Embedded Flaw Repair SER Discussion and Comments August 7, 2003

Warren Bamford
Jack Lareau
Nuclear Services

SER on Embedded Flaw Repairs

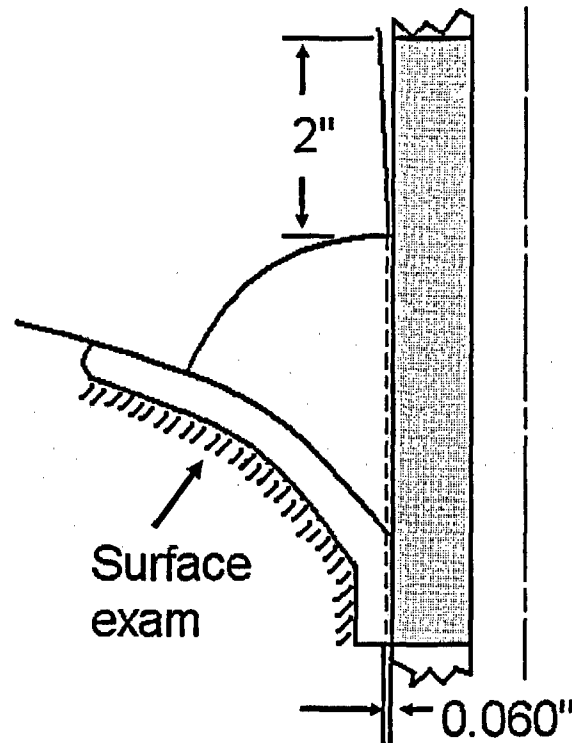
- Perform the same inspection as for non repaired condition (ET and UT)
- Mockup testing - consistent with previous slide
 - Previous testing used saw cut flaws
 - Use CIP flaws similar to MRP mockups

↳ EPRI WILL MAKE FLAWS.

Exam Coverage: J-Groove Weld Repair

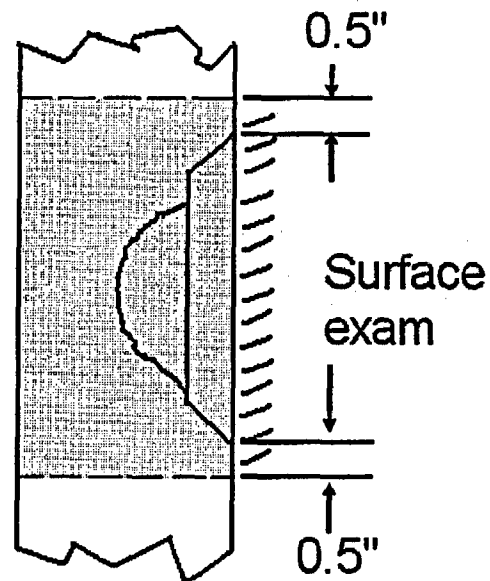
- Inspection requirement per SER: UT plus surface exam coverage must equal 100 percent
- Weld OD repaired surface is considered not accessible for meaningful UT
- UT inspection is from the tube ID, looking at the triple point to detect flaw growth and/or leak path
- UT demonstration complete (MRP Interim Report, 12/02)

- Weld overlay is a non-structural corrosion resistant seal weld (cladding)
- PT after seal weld repair and for ISI
 - ASME requirement is PT plus VT for ISI
- Assumed flaw is entire cross section of weld
- Volumetric exam will be performed from the nozzle ID
 - Monitor for flaw growth beyond the maximum assumed (and analyzed) flaw in weld
 - Monitor for possible leak path

-  UT Inspection Volume
-  Surface Exam Coverage
